PUMPHOUSE REVISIONS FOR IRON REMOVAL PLANT

MICHIGAN
DEPARTMENT OF CONSERVATION
PARKS AND RECREATION DIVISION

TAHQUAMENON FALLS STATE PARK
LOWER FALLS CAMPGROUND WATER SYSTEM
Scale 3/4" = 1'-0"

PLAN NO.
E-110 A

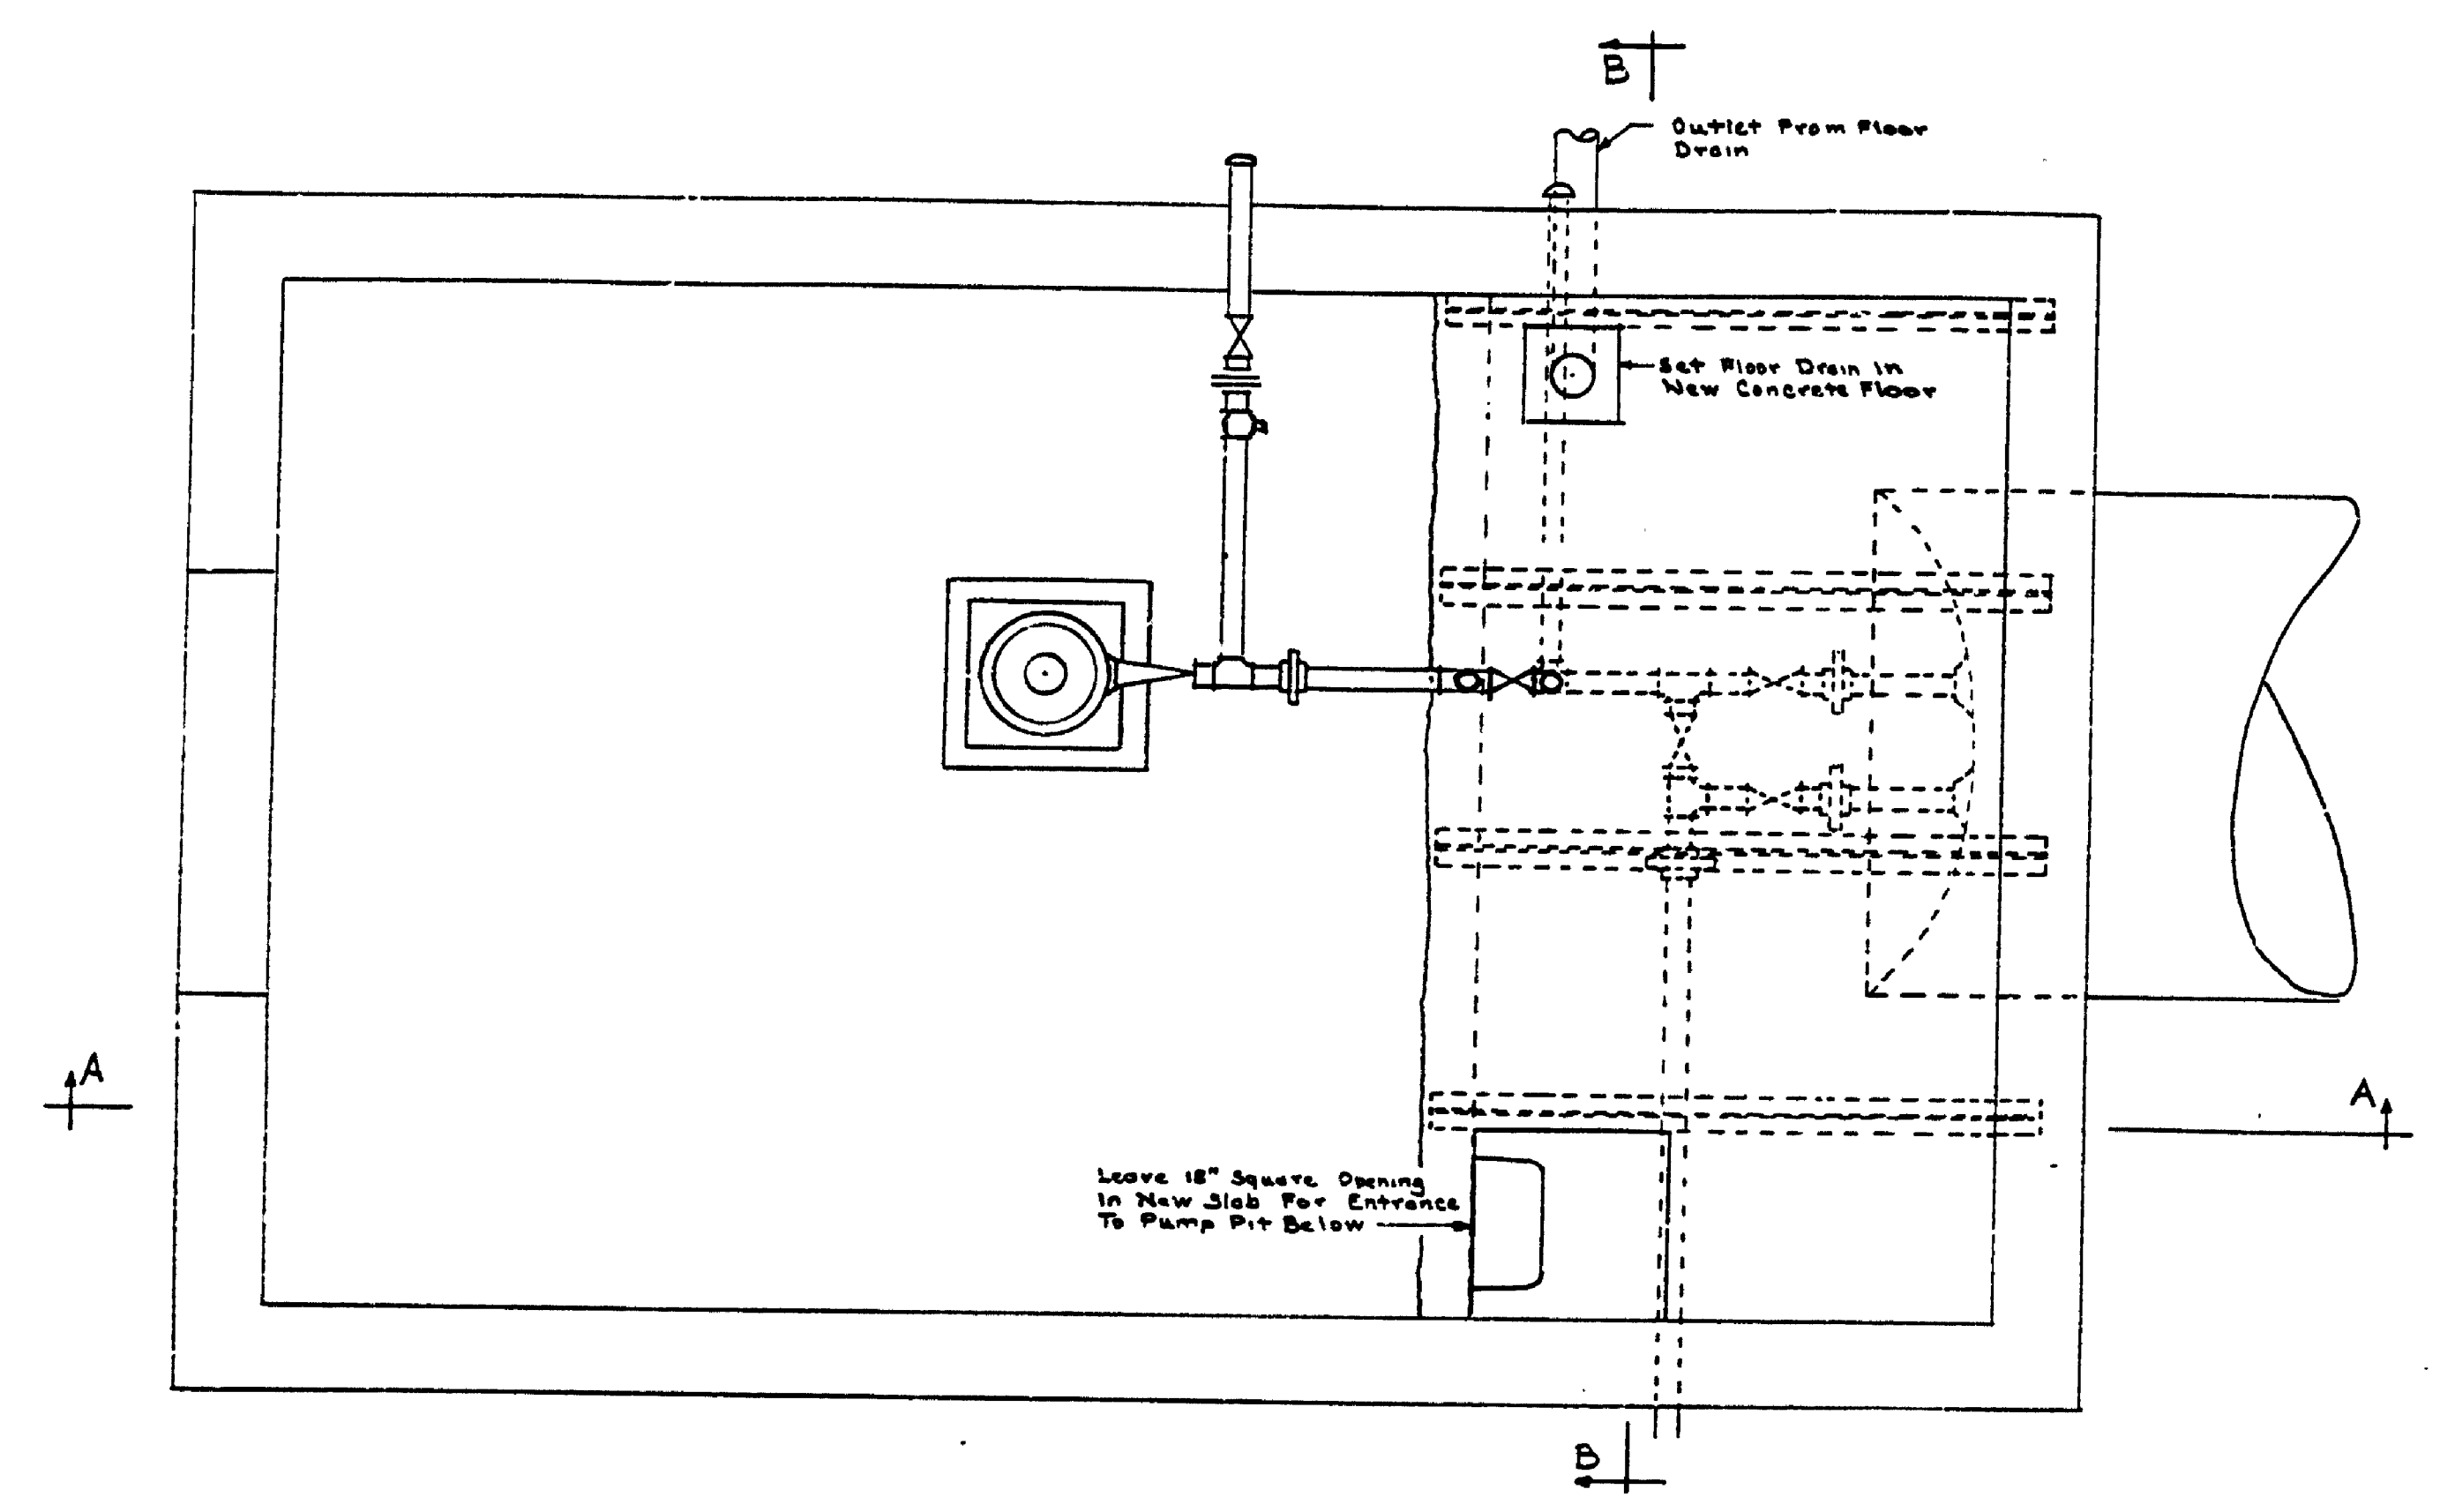
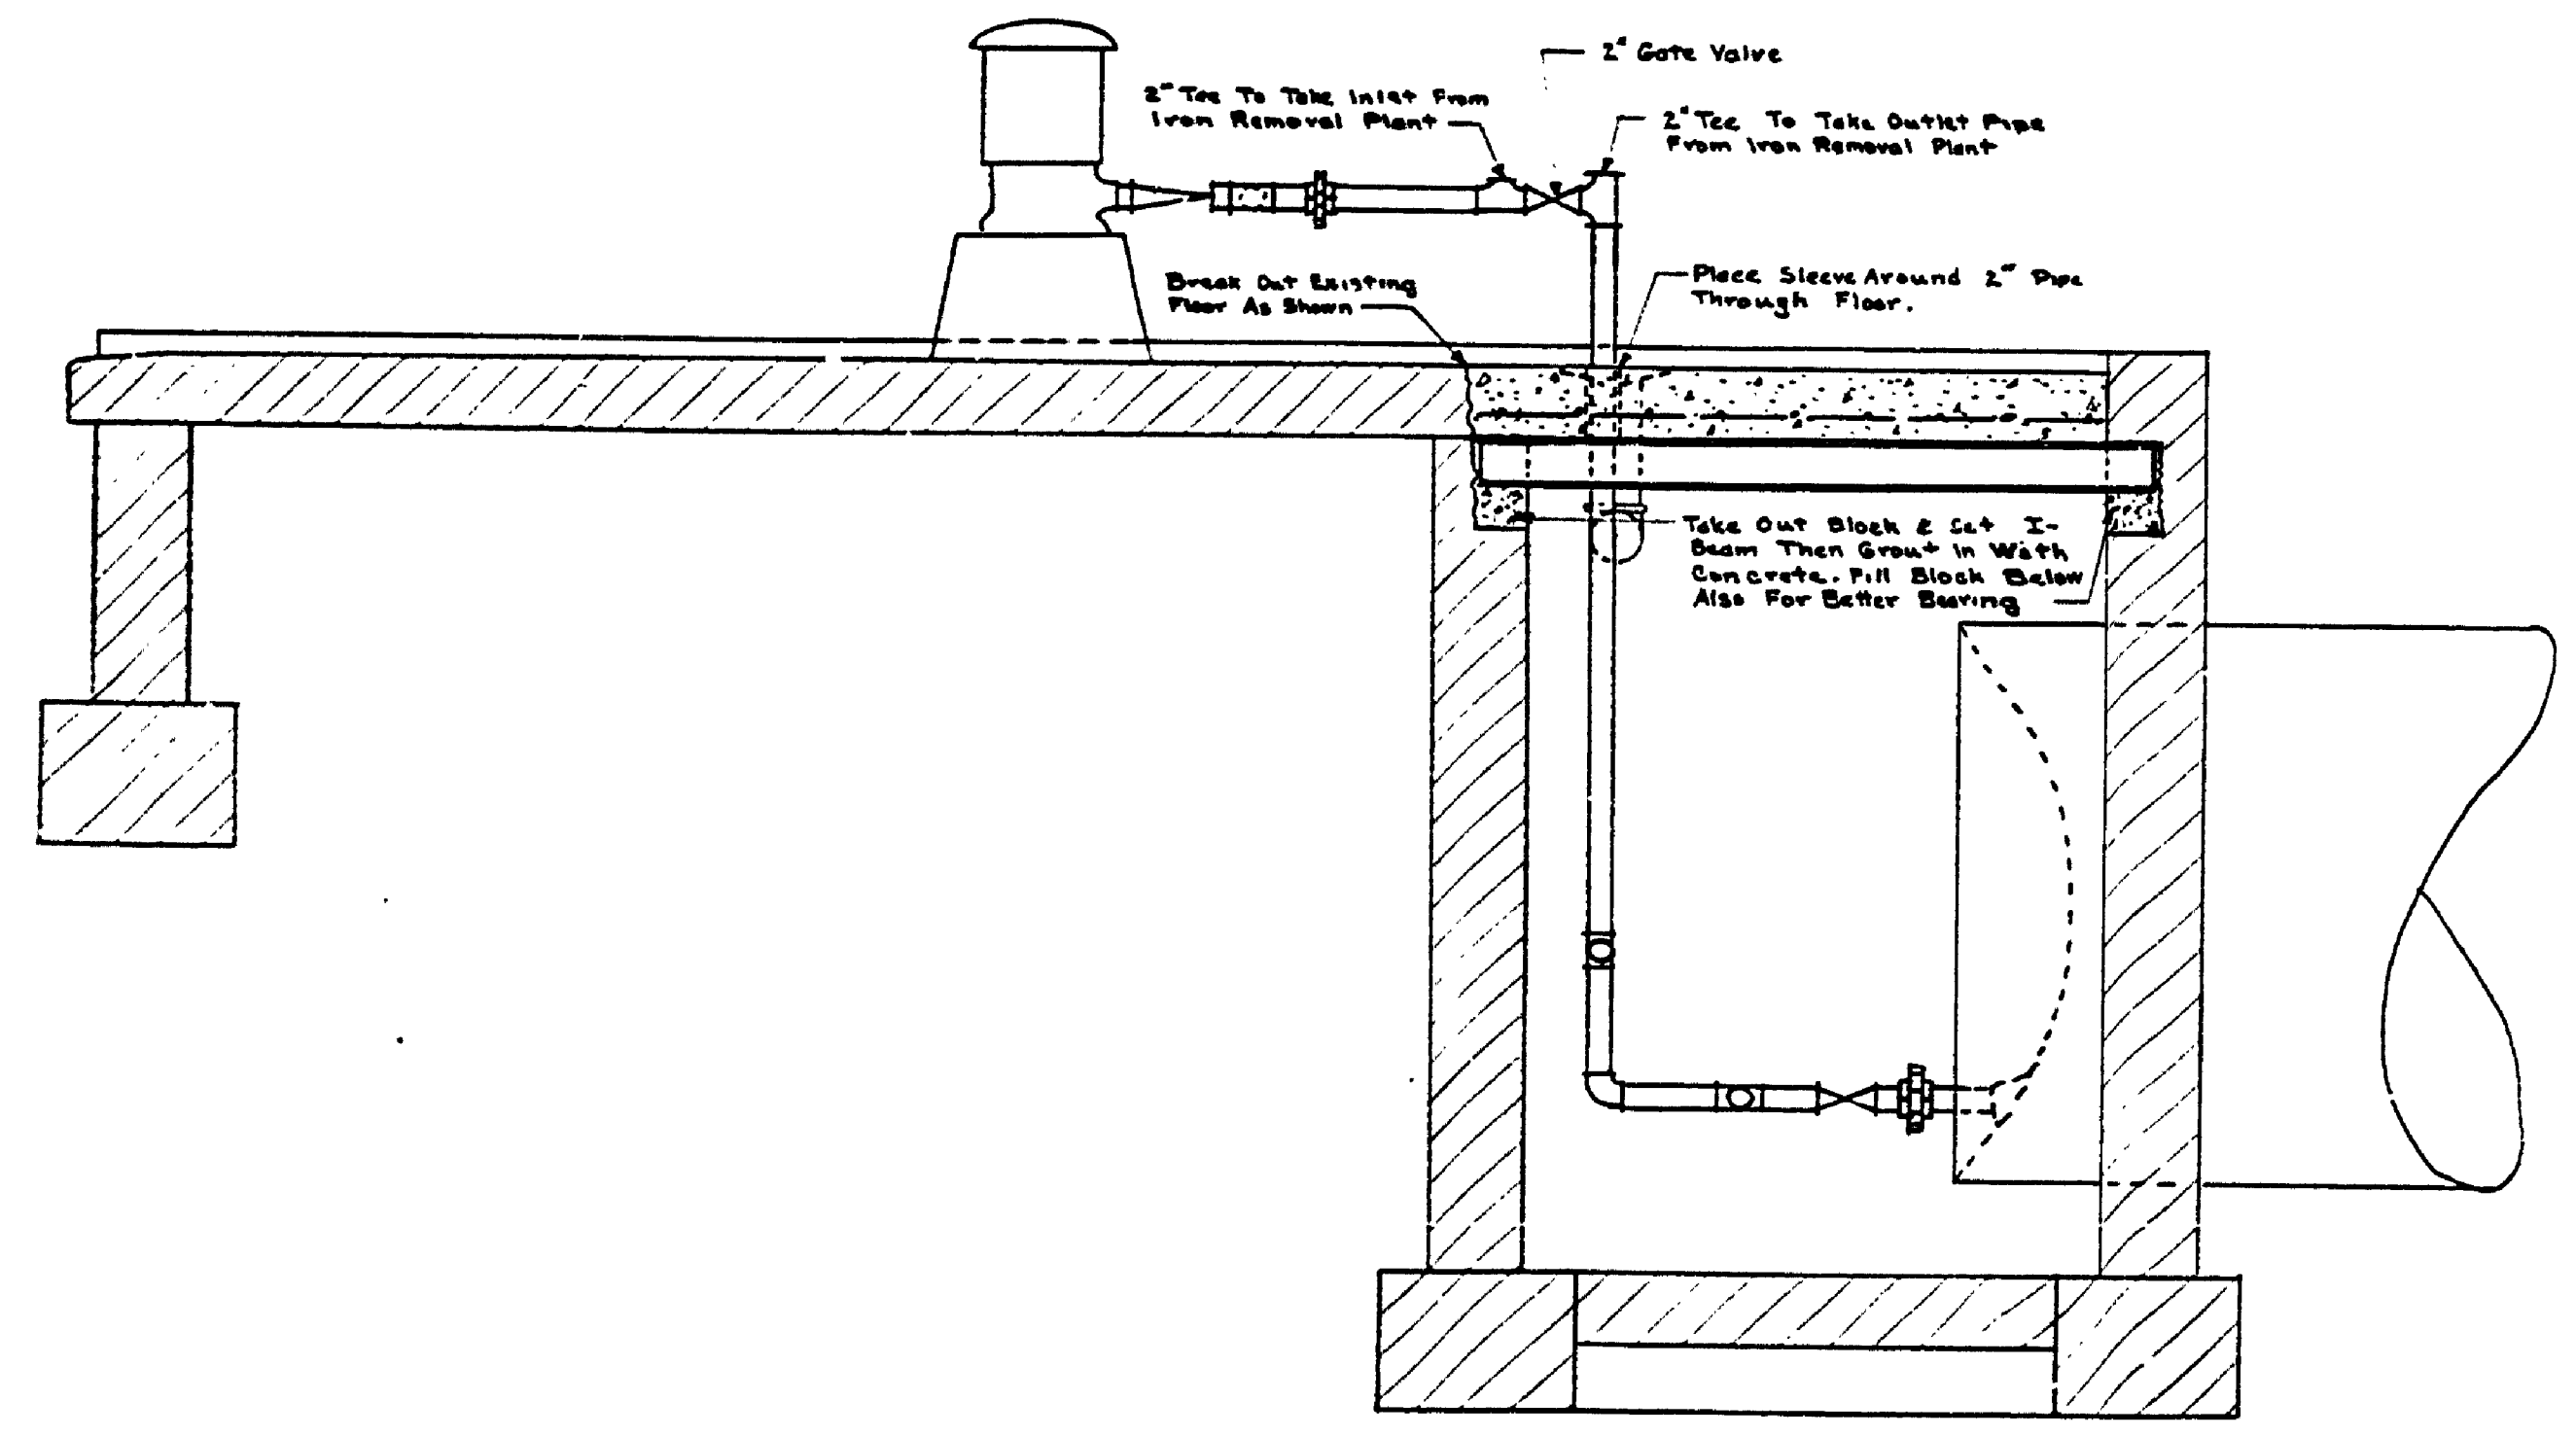
- Notes:
1. Revise Piping 2" Tees & 1-2" Gate Valve As Shown
 2. Break Old Floor Back About 6" The Total Length Of The Pump Pit.
 3. Break Out The Blocks Necessary To Set I-Beams As Shown
 4. Fill Blocks Below I-Beams With Concrete For Better Bearing
 5. Set I-Beams And Grout In With Concrete
 6. Do NOT Pour Floor Until Grout Around I-Beams Is Well Cured
 7. Be Sure Floor Drain is Set Before Pouring Floor
